## Submission on Medium Density Housing By Matt Mushalik

### Government forces Sydney to go substandard on miniature lot sizes Uncontrolled overseas migration and lack of decentralisation

#### A Explanation of intended effect

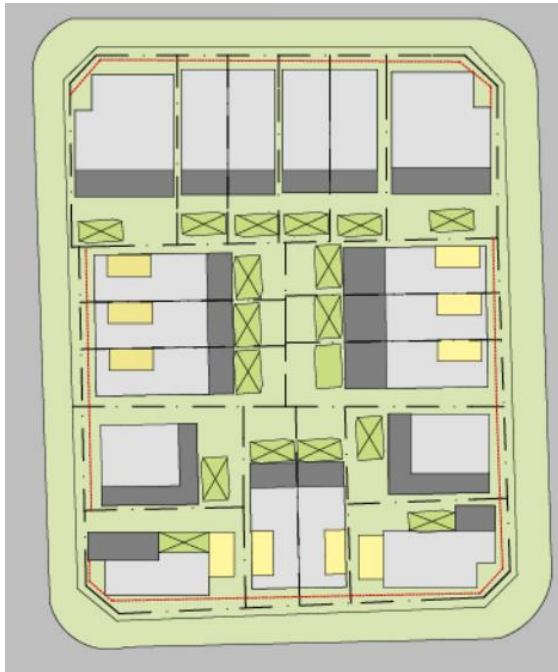
<< This looks like a high density working class block in Redfern.

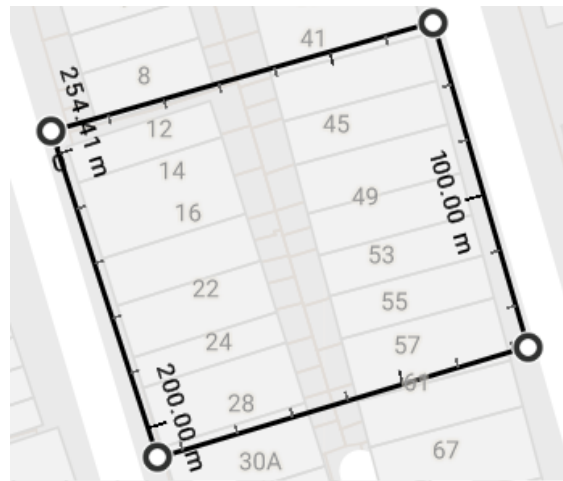
Although no dimensions are given, the size must be approximately  $50 \times 80 \text{ m} = 4000 \text{ m}^2$  with 18 dwelling units giving an average size of  $222 \text{ m}^2$  per dwelling.

Similarly sized block in Redfern >>

The government wants this for all of Sydney? Yes, let's start with it in the suburb of the Premier Mike Baird, in Manly and then continue with the suburbs of all other decision makers who had the brilliant idea for this design guide.

Figure 2-27 Internal pedestrian network

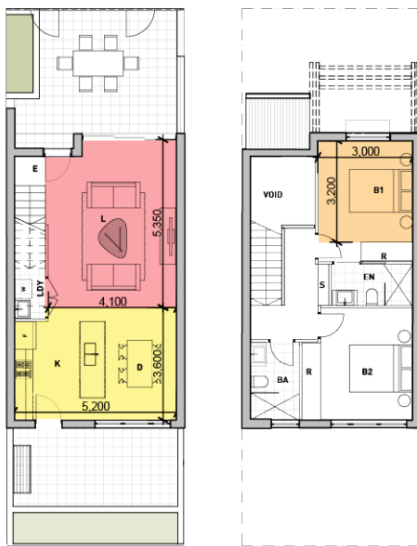
<< this design example is of lower density than shown above. It is misleading.
